F087
SERVICE BULLETIN

INCORRECT CRANKSHAFT SPACER USED ON 27HP KOHLER IS2000Z MODELS

MODELS AFFECTED			
Brands	Model Nos.:	Serial No. Range:	Description:
Ferris	5901170 5900625	2000666746 & below.	IS2000Z, 27 HP Zero-Turn Riding Mower w/52" & 61" mower deck.

Figure 1. Inspecting the Machine
A. Crankshaft Pulley
B. 5/8" Bolt
C. PTO Clutch
D. Crankshaft Spacer

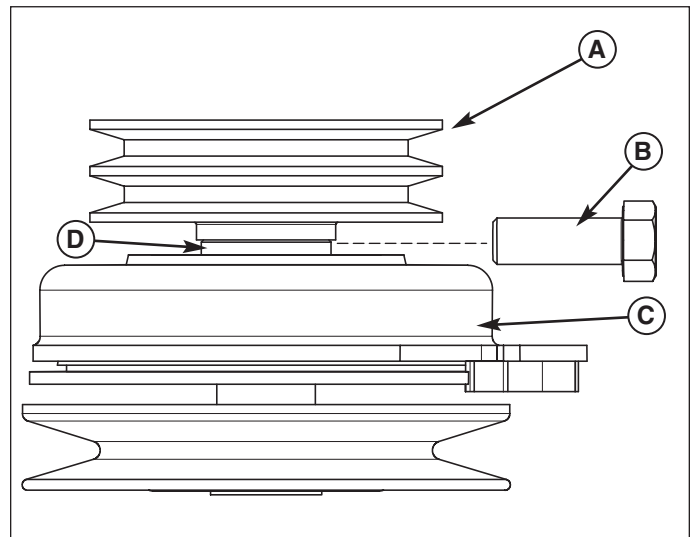
Field reports indicate that an incorrect length spacer is causing engine crankshaft failures on some units in the field that are within the serial number range listed above.

1. Park the machine on a flat, level surface and engage the parking brake. Disengage the PTO switch, turn off the engine and remove the key from the ignition.
2. To evaluate whether the unit is affected, place a 5/8" bolt (B, Figure 1), (P/N #5025320X14 which is a 5/8-11 X 1-3/4" bolt, will work in this instance) between the crankshaft pulley (A) and the PTO clutch (C). If the shaft of the bolt slides in and makes contact with the spacer, the unit is not affected and no further action is required. If the shaft of the bolt does not slide in and make contact with the spacer, continue with the following corrective procedure.

1. Order and install Service Kit # 5600094.
